Access Compliance Report

Public Rights-of-Way

Intersection ID: 2501	Main Street: BENTGRASS_RUN_DR	Cross Street: WHISTLER'S_CHASE_DR	Location: E
ADA ID: 08F314E32747	Ramp Type: PerpDiag	Initial Pass/Fail: Fail	Overall Compliance: No
Codes/Mitigation Info/Possible Solution		Field Measurements/Component Compliance	
Severity Score: 13.75

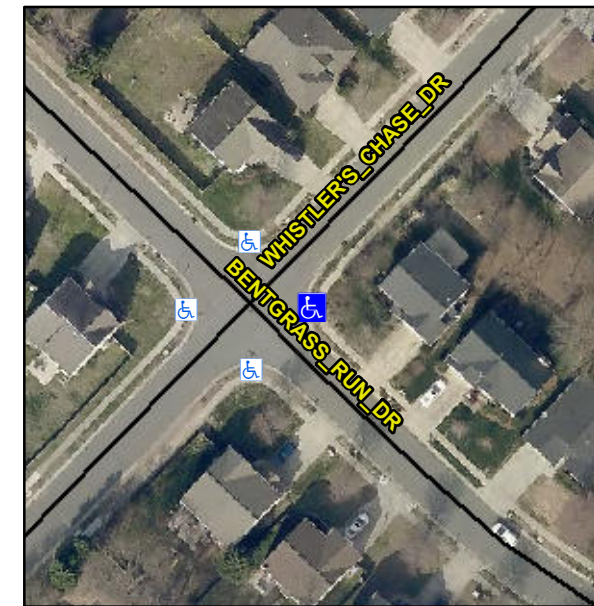
Not Found, R304.2.2, R304.5.3

Compliance	Description	Data	Compliance	Description	Data
N/A	Ramp Length (in)	49.0	No	Ramp Slope (%)	9.6
Yes	Ramp Width (in)	60.0	No	Ramp XSlope (%)	2.2
N/A	Flare Type LT	N/A	N/A	Flare Type RT	N/A
N/A	Flare Slope LT (%)	N/A	N/A	Flare Slope RT (%)	N/A
N/A	Flare Traversable LT?	N/A	N/A	Flare Traversable RT?	N/A
N/A	Landing Length (in)	N/A	N/A	DWS Provided?	N/A
N/A	Landing Width (in)	N/A	N/A	DWS Contrast?	N/A
N/A	Landing Slope (%)	N/A	N/A	DWS Length (in)	N/A
N/A	Landing X Slope (%)	N/A	N/A	DWS Full Width?	N/A
N/A	Landing Curb? (Y/N)	N/A	N/A	DWS Offset (in)	N/A
N/A	Shared Landing?	N/A			
N/A	Gutter Ponding?	N/A	N/A	Gutter Slope (%)	N/A
N/A	Gutter Lip Ht (in)	N/A	N/A	Gutter X Slope (%)	N/A
N/A	Painted X Walk1?	No	N/A	Painted X Walk2?	No
	X Walk 1 Direction	To NW		X Walk 2 Direction	To SW
N/A	X Walk 1 Width (in)	N/A	N/A	X Walk 2 Width (in)	N/A
	X Walk 1 Slope (%)	7.0		X Walk 2 Slope (%)	3.7
	X Walk 1 X Slope (%)	0.4		X Walk 2 X Slope (%)	5.2

Remove & Replace Curb Ramp With Two New Directional Ramps or Equivalent.
